MWRA'S WALPOLE RESIDUALS LANDFILL
IMPACT ON LOCAL
DEPARTMENT OF CORRECTION
FACILITIES

PREPARED FOR
OFFICE OF PROGRAMMING
DIVISION OF CAPITAL PLANNING AND OPERATIONS
EXECUTIVE OFFICE OF ADMINISTRATION AND FINANCE
COMMONWEALTH OF MASSACHUSETTS
JANUARY, 1993

MASS. STATE PROJECT NO. DCP 91-9 S02

ALMER HUNTLEY, JR., & ASSOCIATES, INC.
SURVEYORS - ENGINEERS - LANDSCAPE ARCHITECTS

LOCUS MAP

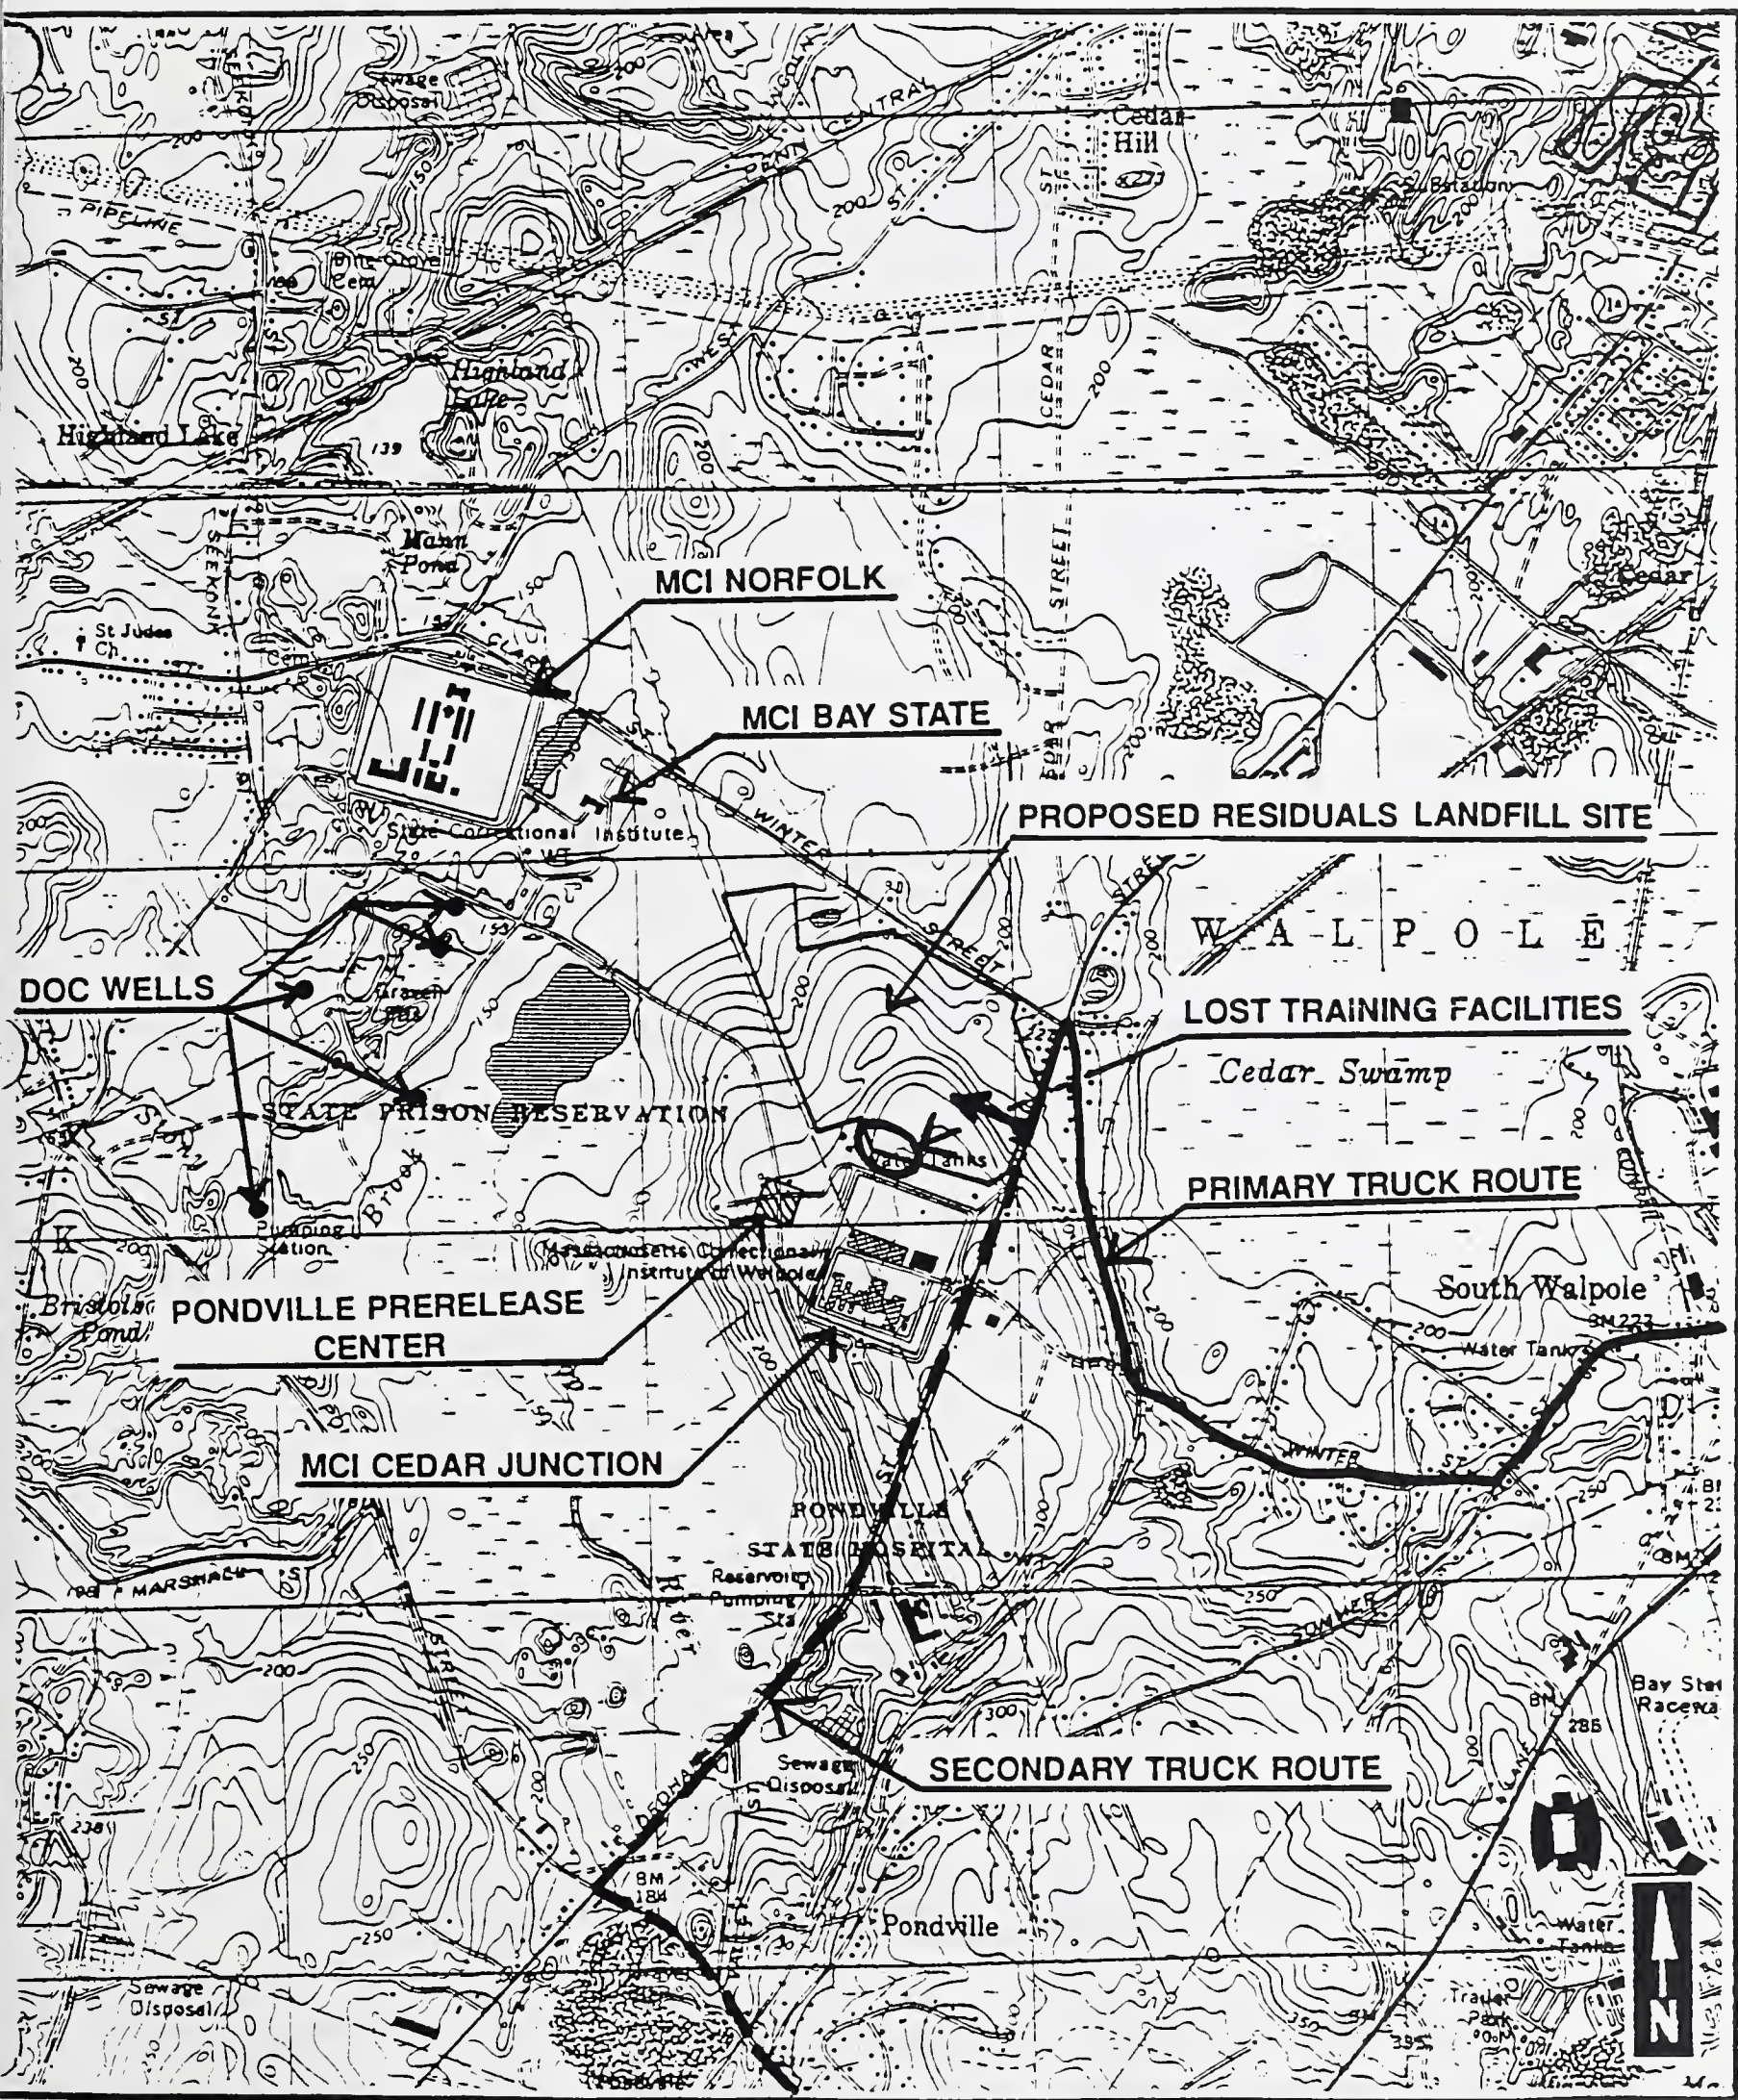
The attached locus map shows DOC facilities, the proposed landfill site and truck routes.

SCHEMATIC DIAGRAM OF SIGHT LINES

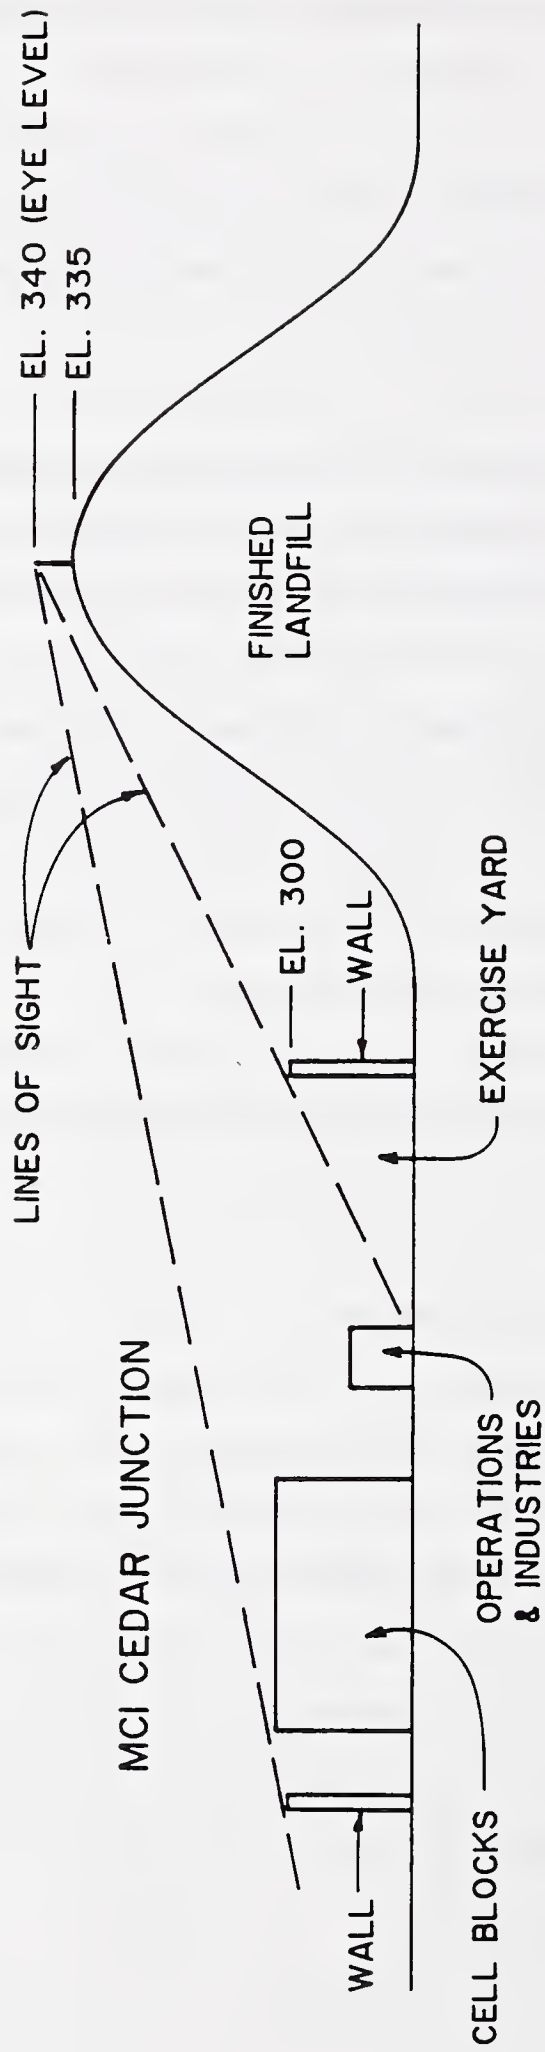
According to construction plans prepared by Wehran Engineering, October 1992, the high point of the finished landfill will be elevation 335. This high point is approximately 800 feet from the prison wall, which has a top elevation of about 300 feet. Thus an observer standing on the high point with eye level five feet above the ground would be able to observe the prison yard south of a line that is about 400 feet from the north wall. This line is approximately the north side of the operation and industrial buildings which border the exercise yard. (See schematic diagram of sight lines.)

- (1) Lowering the proposed high point of the landfill to the level of the top of the wall; or
- (2) In addition to the planned landfill fencing,
 - (a) Provision of permanent night time illumination of the landfill above elevation 300; and/or
 - (b) Provision of infrared sensors or other electronic means to detect intruders on the landfill.
